EAST TRAILS MIDDLE SCHOOL - PRECAST 3" METER VAULT CONSTRUCTION DRAWING REVISIONS
RESPONSE TO CITY COMMENTS
FEBRUARY 7, 2022

WATER METER VAULT DETAIL
NOT TO SCALE

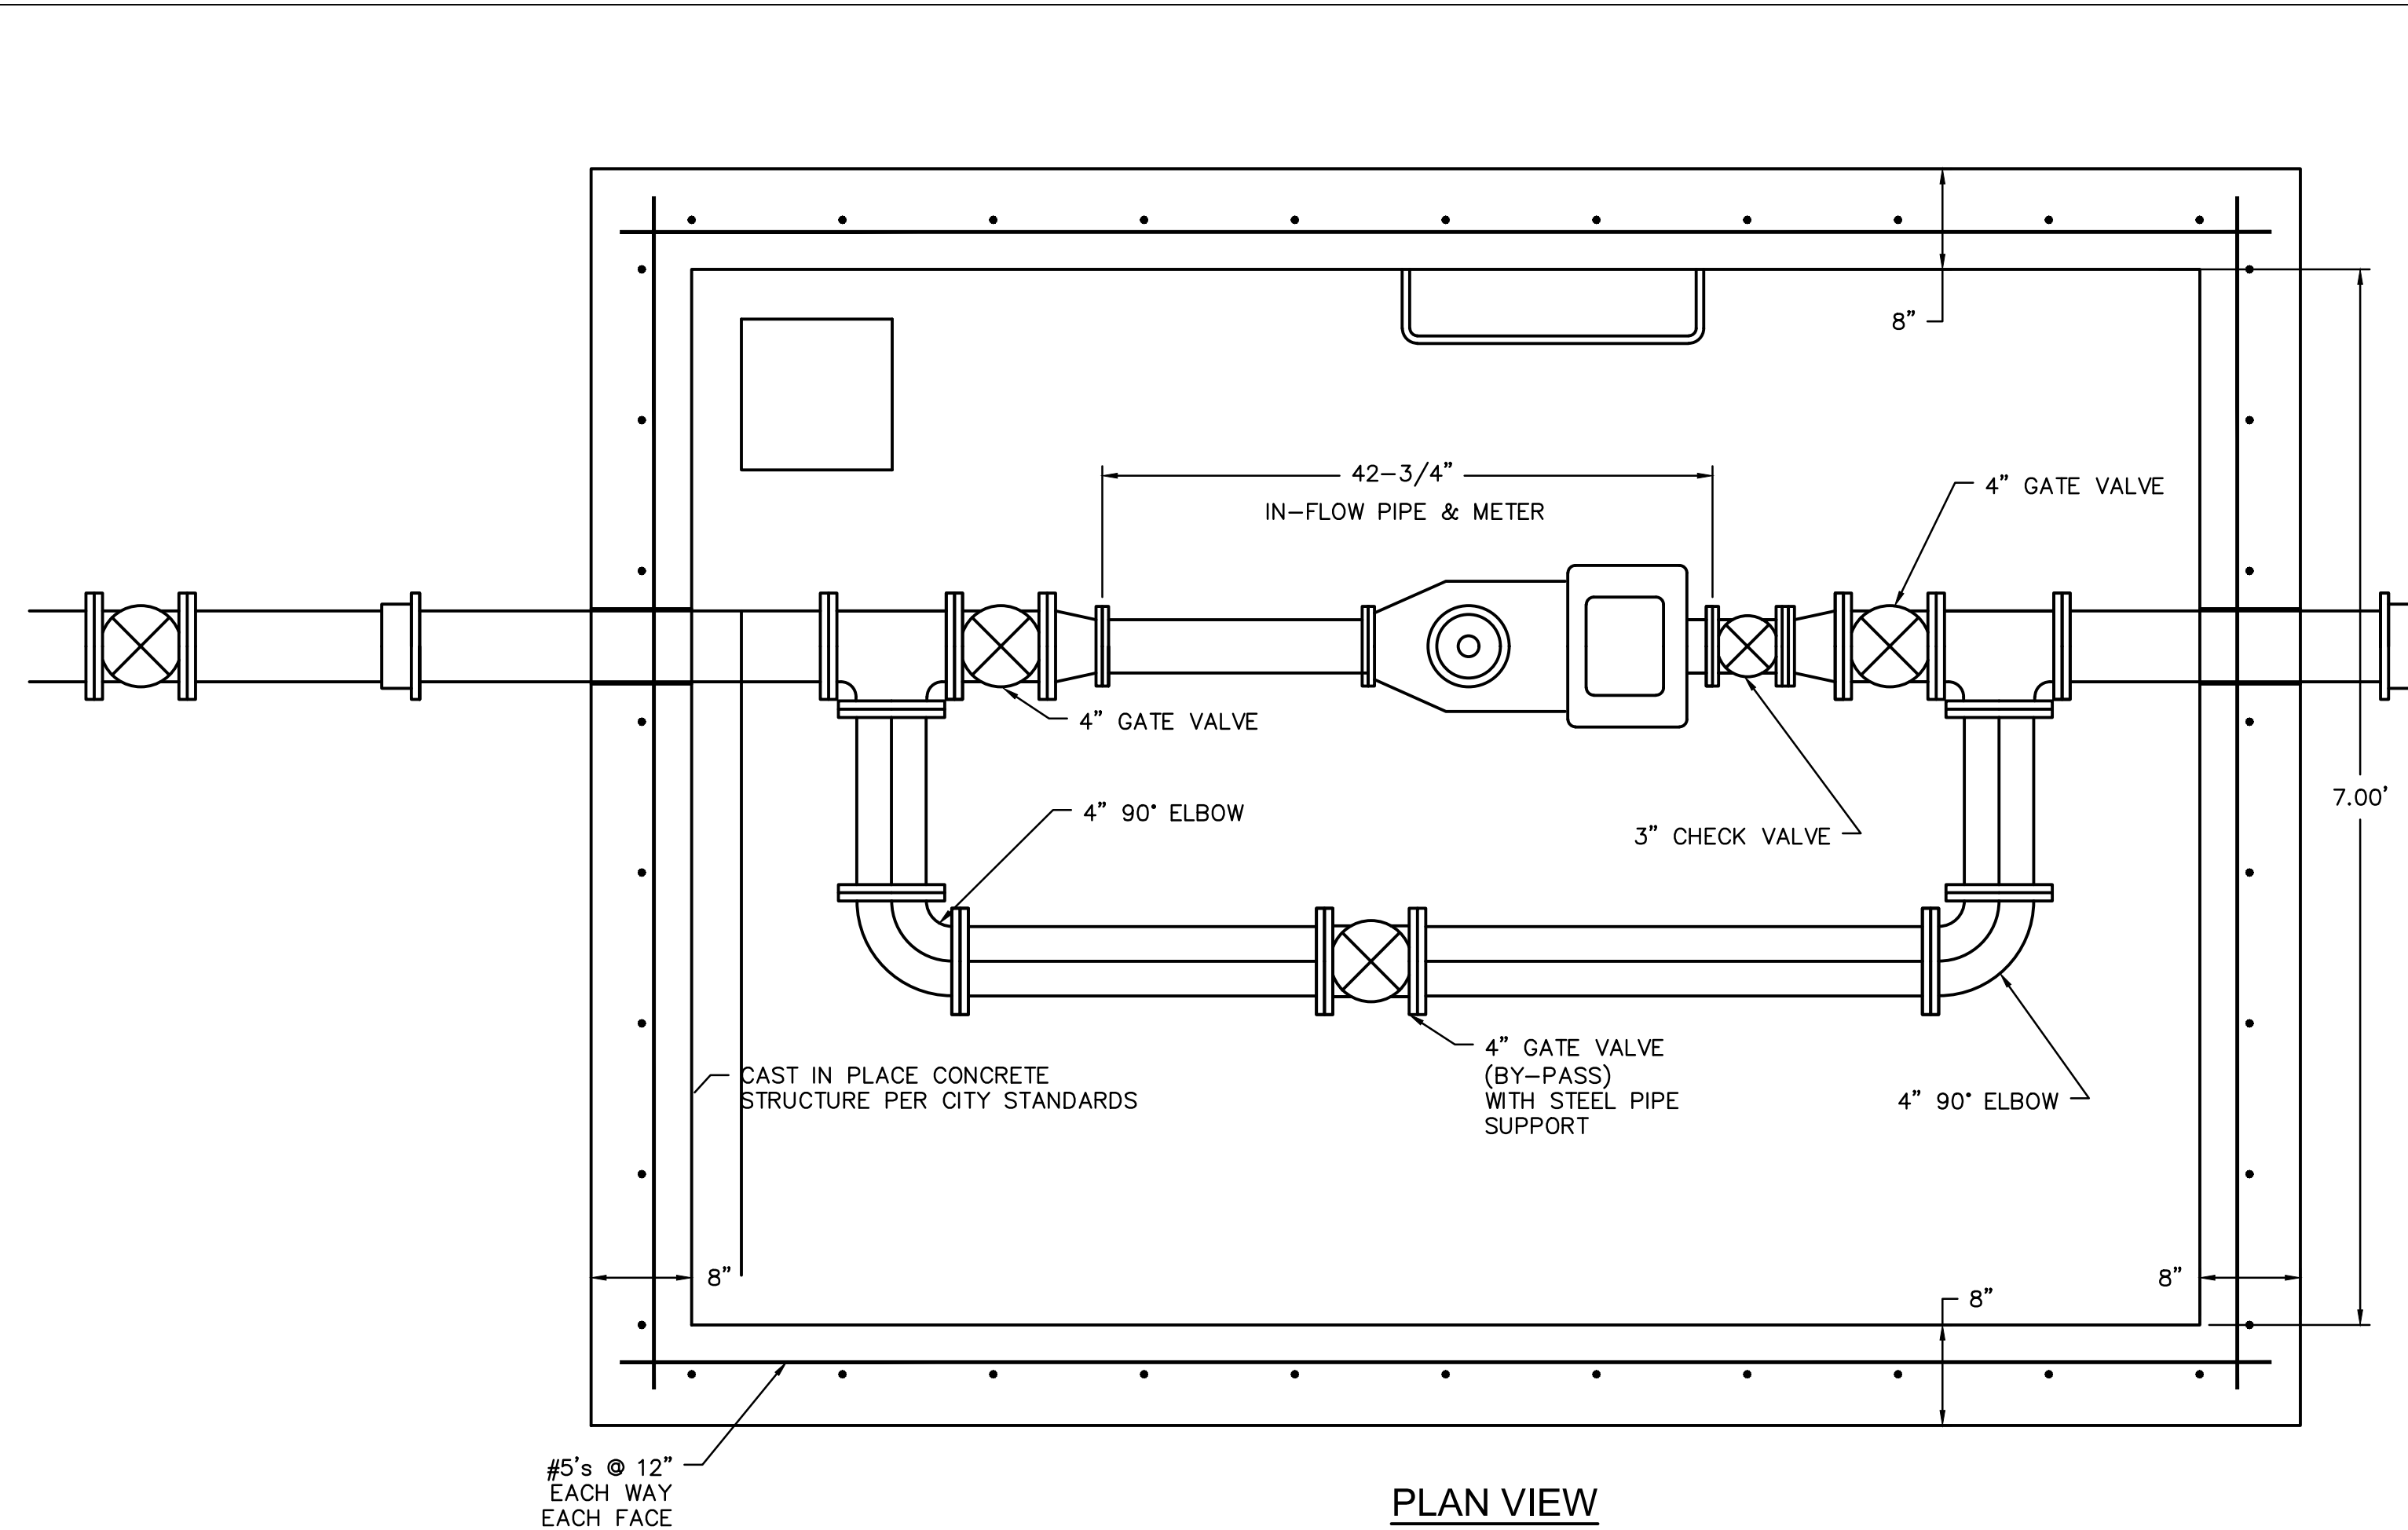
4	Since this is cast in place, where is the leveling mat? A granular leveling mat appears warranted rather than bare earth foundation.	The detail on Sheet C1050A has been revised to include a 2" AB-3 leveling layer under the vault slab.
5	Sump has no mechanism to drain. In a similar fashion to backflow vaults, provide the method to drain the meter vault either by daylighting, connection to a private storm inlet or box, or infiltration gallery. Provide notation on the revision showing how this will be accomplished, and revise the utility plan sheet to reflect the change as appropriate.	A sump has been added to the detail on the new Sheet C1050A. Sheet C1027 has been updated to show a 2" PVC drain connection to this sump (Keynote BD-2). This drain is being wye'd into the drain for the Backflow Preventor Vault.
